Interactive comments on “Model study on potential contributions of the proposed Huangpu Gate to flood control in Taihu Lake basin”

By Zhang Hangui et al.

Liu Shuguang et al.

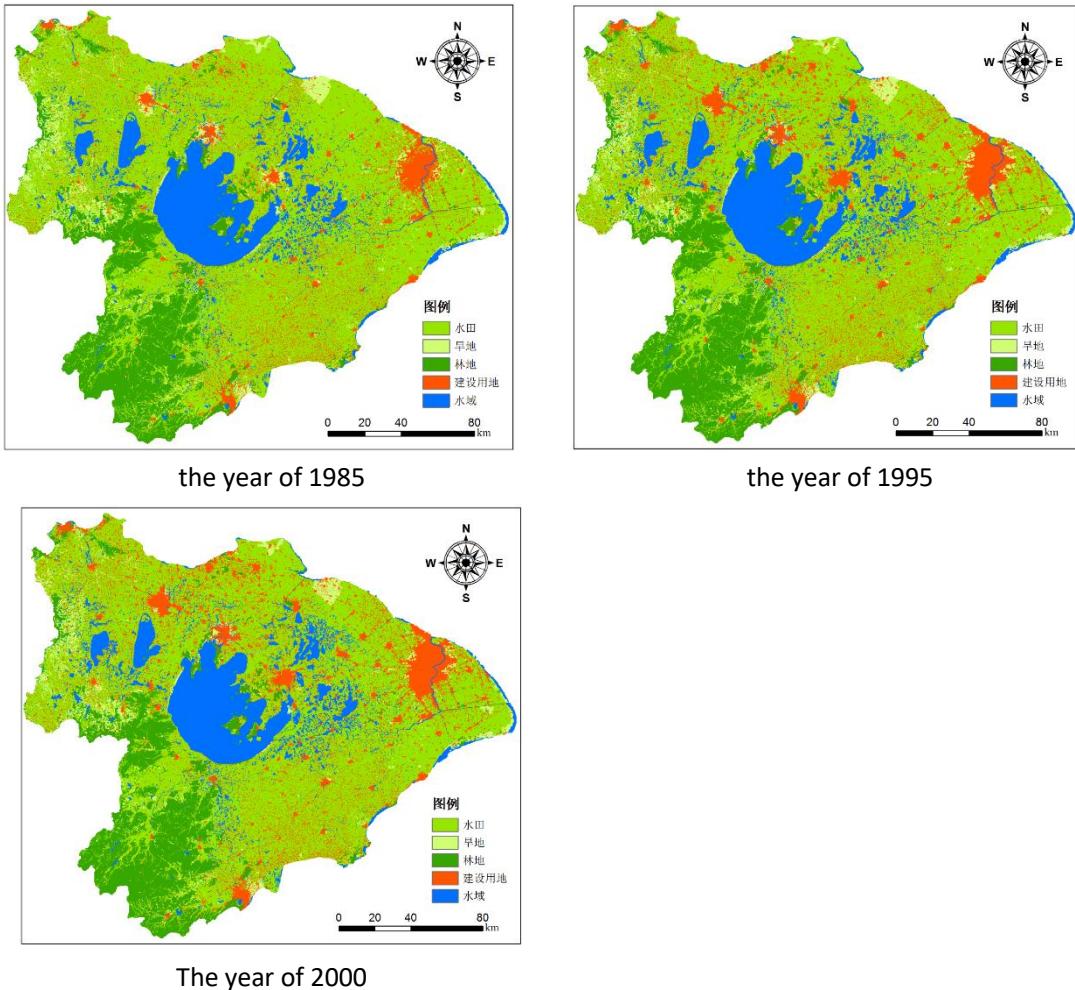
(9) Page 4 Line 27: please provide more details on the runoff-generation processes for different surface types.

“Cheng et al. (2006)” is the main reference book which provides a lot of information about the HOHY model listed in the reference of our manuscript (Page 10 Line 25), more details can be found in Chapter 2 of this book. In addition, “Jin. (2008), page 49-51” also provides the details on the runoff-generation processes for different surface types. Simple explanations are as follows:

a) Water Surface

Runoff production of water surface is the rainfall excess, which can be expressed as the difference between the precipitation and evaporation.

b) Paddy Field

The amount of water which paddies need is changing in different growing periods. Its runoff production changes according to the previous water level.

c) Non-irrigated Farmland

As a plain area with abundant river networks, its ground water table is comparatively high. A model named “runoff yield under saturated storage” is used for calculation.

d) Constructed Ground

These grounds are weak at infiltration. Their runoff production can be simplification as the product of the precipitation and coefficient.
